[Docket No. 2002–SW–42–AD; Amendment 39–12936; AD 2002–17–51]

#### Airworthiness Directives; Agusta S.p.A. Model A109E Helicopters

**2002-17-51 Augusta S.p.A.:** Amendment 39-12936. Docket No. 2002-SW-42-AD.

**FIGURE 1**

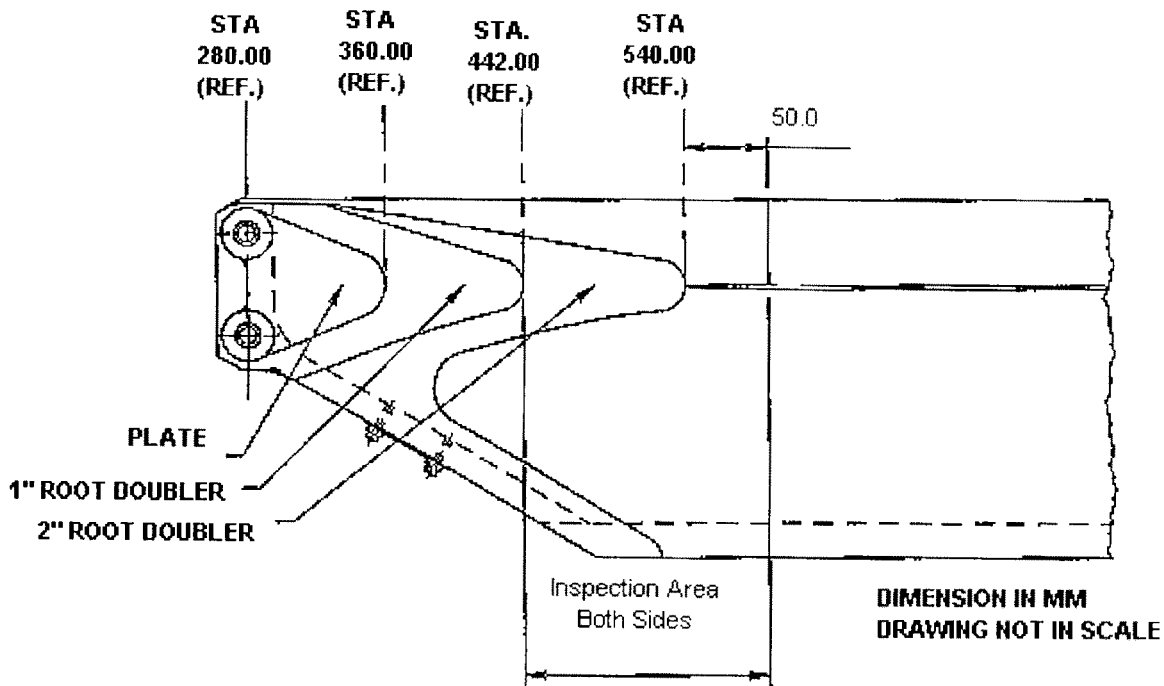
(b) Before each start of the helicopter engines, visually check both sides of each tail rotor blade for a crack in the area depicted in Figure 1 of this AD. And owner/operator (pilot) holding at least a private pilot certificate may perform this visual check and must enter compliance with this paragraph into the aircraft maintenance records in accordance with 14 CFR 43.11 and 91.417(d)(2)(v). See Figure 1:

**Note 2:** Paint irregularities on the tail rotor blade may be due to a crack.

(c) Within 25 hours time-in-service (TIS), and thereafter at intervals not to exceed 25 hours TIS, and anytime there is an increase in vibration levels, using a 5x or higher magnifying glass, visually inspect each tail rotor blade for a crack before further flight in accordance with the Compliance Instructions, Part III, paragraphs 1. through

(d) Replace any cracked tail rotor blade with an airworthy blade before further flight.
